May 2nd 2014.

Chairman and Members
Scarborough Community Council

RE: McCOWAN PRECINCT STUDY

Source: Tables 13 and 21. ARUP Canada report, May 2013.

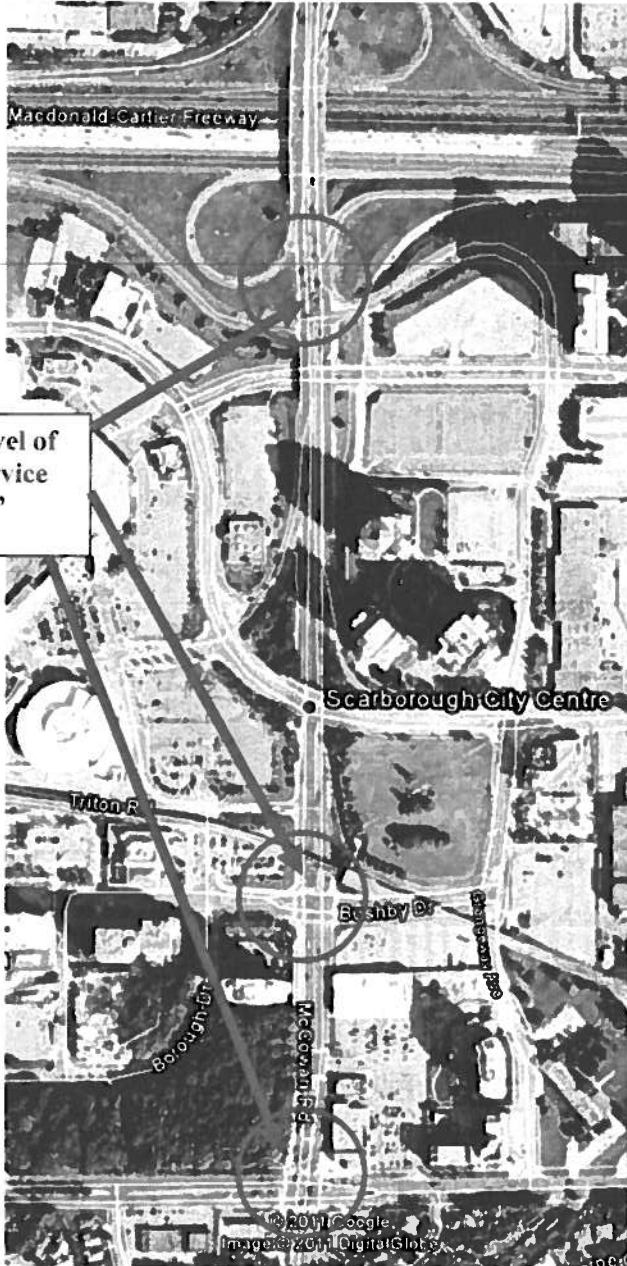
It's hard to understand that McCowan-Ellesmere will somehow improve from a Volume/Capacity ratio of 2.32 in today's afternoon peak hour to only 1.93 in the future when all the expected development takes place. Or that the morning rush hour at this intersection will somehow drop from today's 1.30 to 1.09 Volume/Capacity.

Setting that aside, no matter how you cut it, it looks like our main road to and through the Centre will be at the lowest possible level of service available on the engineer's scale... "considered unacceptable by most drivers".

The consultant's report does not put forward anything which would add significantly to the capacity of the road system to handle the expected volume of traffic.

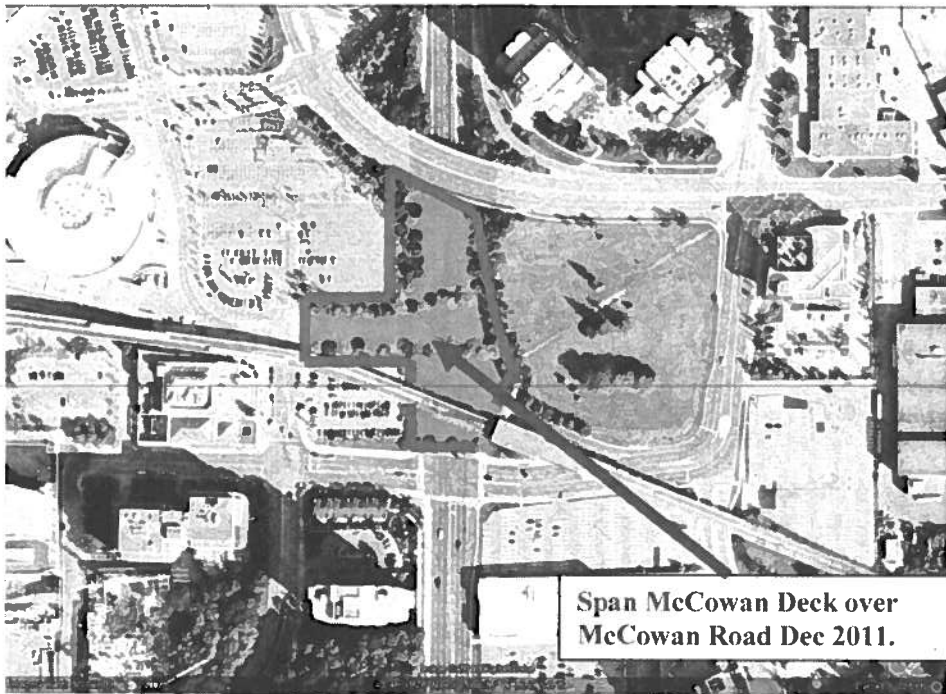
As we have pointed out before, this part of McCowan is down in a ditch. It is much lower than the surrounding properties. Pedestrians have to walk down to this Level of Service F intersection full of frustrated cars, truck and buses, wait their turn to cross and then trudge back up on the other side.

Why?

How is that safe for people with movement disabilities, people with limited sight, people in wheelchairs or using walkers, people carrying children to/from day care?

Why would you force pedestrians to make that movement when there is a perfectly delightful and 100% safe alternative available with a little vision and courage?

That the Chief Planner retain qualified engineering consultant services to prepare preliminary designs together with feasibility studies and preliminary cost estimates to build a pedestrian deck across McCowan Road in the area between the RT overpass structure and the Progress Bridge to provide a safe, direct and attractive grade-separated crossing of this major arterial road for pedestrians, cyclists, and people with movement challenges uniting the two neighbourhoods on either side of McCowan Road. Deck designs shall advance beyond purely utilitarian and be of sufficient width to create attractive public space including landscaping and public art but not classified as a 'tunnel'.

Bushby to McCowan northbound lane, RT Station on left, pedestrian overpass ahead.

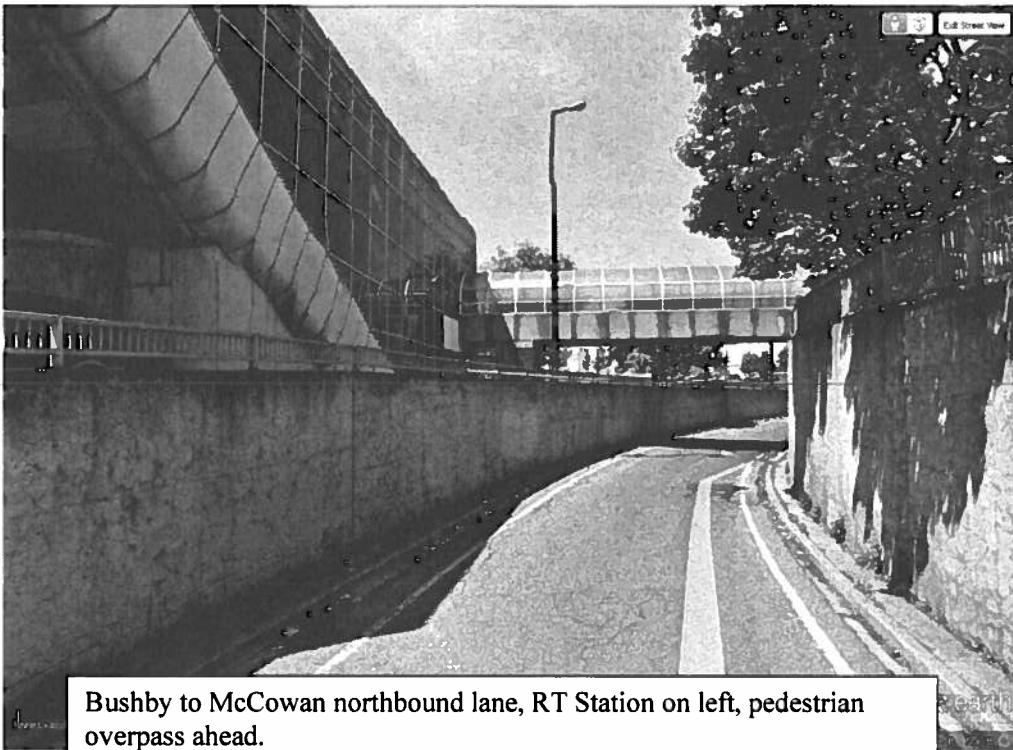
To make matters worse at the McCowan-Bushby-Town centre Court intersection ARUP proposes that the westbound Bushby right turn lane to McCowan northbound be removed.

This lane allows vehicles to avoid all pedestrian movements at the McCowan-Bushby intersection. It dives down under a pedestrian bridge and comes up again on McCowan northbound as a free flowing on ramp.

If it is taken out as proposed, all right turns would be forced through the intersection which is already operating at Level of Service F. Every right turning vehicle would conflict with the highest pedestrian cross movements in our Centre.

Why would you spend scarce public monies to tear out this free flow lane and demolish a pedestrian overpass to force greater pedestrian-vehicle conflicts at a Level F intersection?

2. Council should NOT APPROVE any proposal to remove the existing westbound Bushby to northbound McCowan free flow until an EA for Bushby to Markham Road has been dealt with.
